1964 Corvette: Engineering Service Letter: Muncie Four Speed Transmission Design Change

ENGINEERING SERVICE LETTER

SUBJECT: MUNCIE FOUR SPEED TRANSMISSION - 1964 DESIGN
CHANGE AFFECTING PAST MODELS SERVICE REPLACEMENT
AND A FIELD FIX IF REQUIRED

DATE 8-20-63
SECTION 7
MODEL RPO M20 800-
1200-1600-1800 & RPO
M21-1200-1600-1800-1963

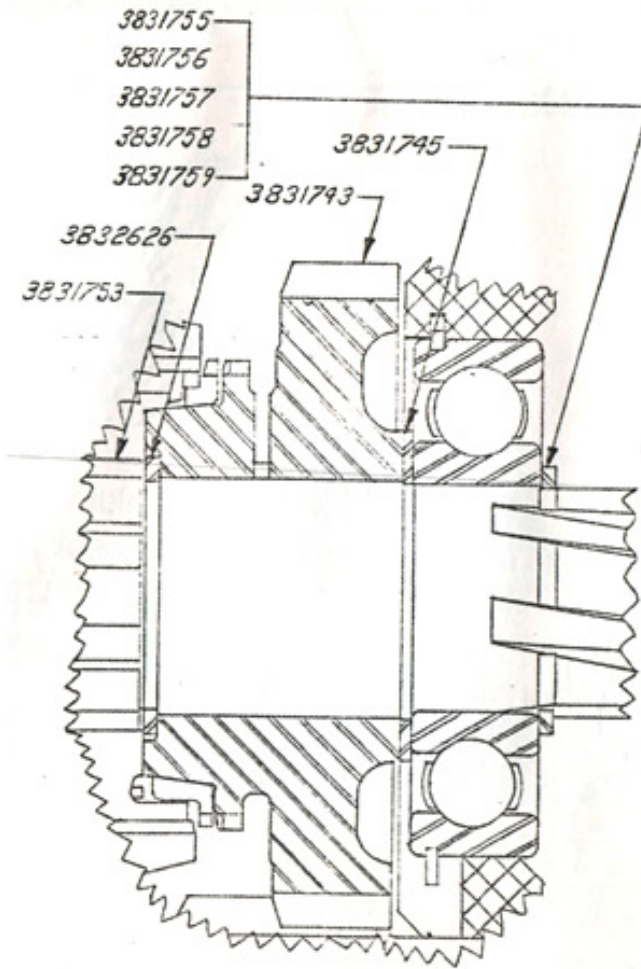
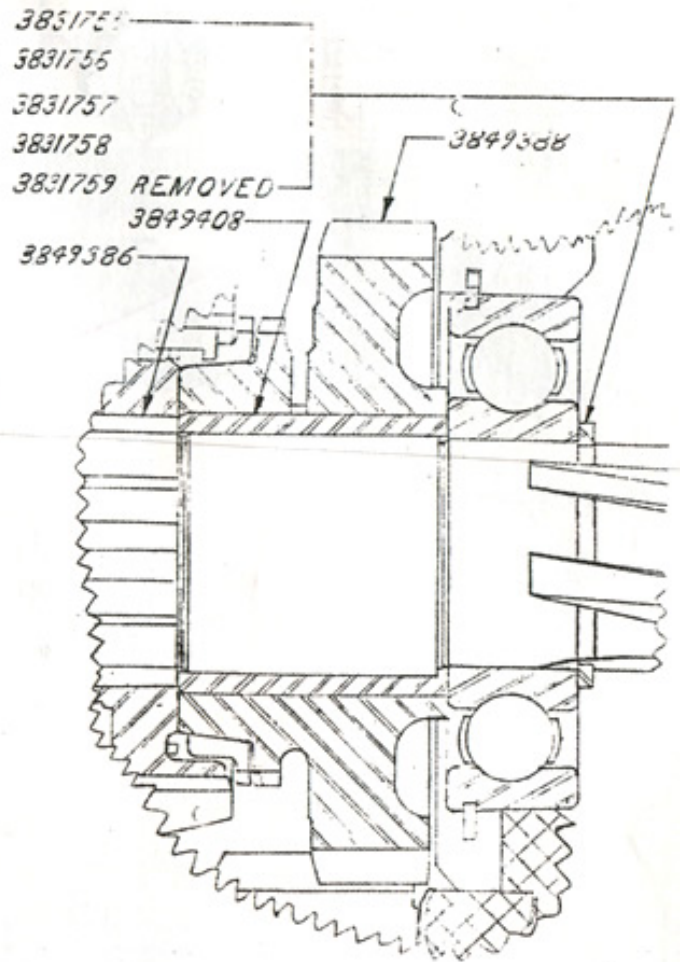
A design change is being introduced for start of production 1964 on subject transmission which includes a new transmission mainshaft, first speed gear, and first speed gear sleeve. The new parts are not interchangeable as details for service replacement on past models. The reasons for the changes are to provide positive first speed gear end clearance, and also to eliminate the possibility of seizure between the inside diameter of the first speed gear and the matching mainshaft outside diameter by use of a new sleeve. The seizure has been reported from the field in several instances at relatively low mileage, and the new parts indicated above are to be used for past model service replacement if this type of transmission failure is noted.

For a comparison between the new and old design in the transmission area affected see attached sketch. Old parts indicated by an asterisk (*) are no longer required as part of revised design.

<u>New Parts</u>	<u>Old Parts</u>	<u>Name</u>	<u>Production Disposition</u>
3849386	3831753	Shaft - Trans. Main	Cancelled & Repl. by 3849386
3849388	3831743	Gear - First Speed	Cancelled & Repl. by 3849388
3849408	-----	Sleeve - First Speed Gear	New
-----	*3831745	Washer - 1st Speed Gear Thrust	Cancelled & Not Replaced
-----	*3831759	Ring - Trans. Main Shaft Rear Brg. Retainer	Cancelled & Not Replaced
-----	*3832626	Ring - Trans. 1st & 2nd Synchronizer Retaining	Cancelled & Not Replaced
